**PCN# 20131015000**  
**Qualification of 12mm Tape width for Select Devices**  
**on QFN Package**  
**Change Notification / Sample Request**

<b>PCN Number:</b>	20131015000			<b>PCN Date:</b>	10/18/2013
<b>Title:</b>	Qualification of 12mm Tape width for Select Devices on QFN Package				
<b>Customer Contact:</b>	PCN Manager	<b>Phone:</b>	+1(214)480-6037	<b>Dept:</b>	Quality Services
<b>Proposed 1<sup>st</sup> Ship Date:</b>	01/18/2014	<b>Estimated Sample Availability:</b>	Date provided upon sample request		
<b>Change Type:</b>	<input checked="" type="checkbox"/> Packing/Shipping/Labeling				
<b>PCN Details</b>					
<b>Description of Change:</b>					
Final Notification to announce the qualification from 16mm tape width to 12mm tape width for QFN devices (See Appendix A for the Carrier Tape "From/To" Detail).					
<b>Pack BOM</b>	<b>Package Size</b>	<b>Current</b>		<b>Proposed</b>	
		<b>TI P/N</b>	<b>Details</b>	<b>TI P/N</b>	<b>Details</b>
Tape	3.3x3.3mm	4212589-0004	16mm width	4212589-0018	12mm width
<b>Reason for Change:</b>					
Standardization of tape width size for 3.3x3.3mm QFN packages.

FROM 16mm WIDTH CARRIER TAPE: 4212589-0004

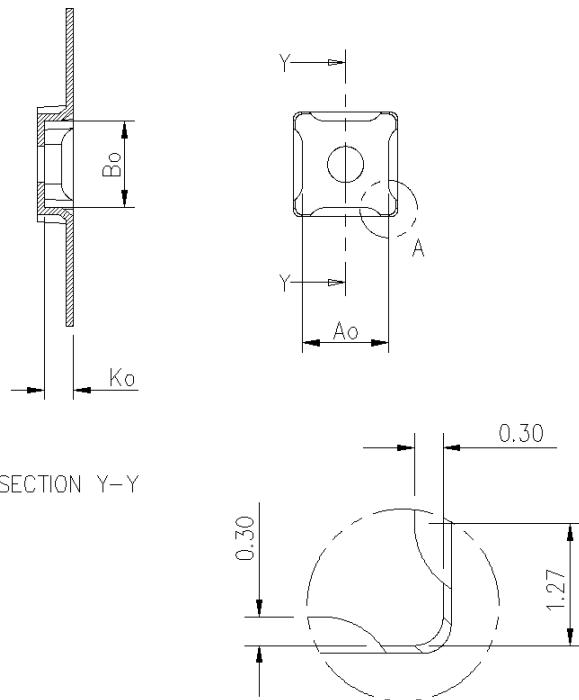
**Appendix A**  
**Carrier Tape “From/To” Detail**  
Change from 16mm width tape to 12mm width tape for VQFN devices
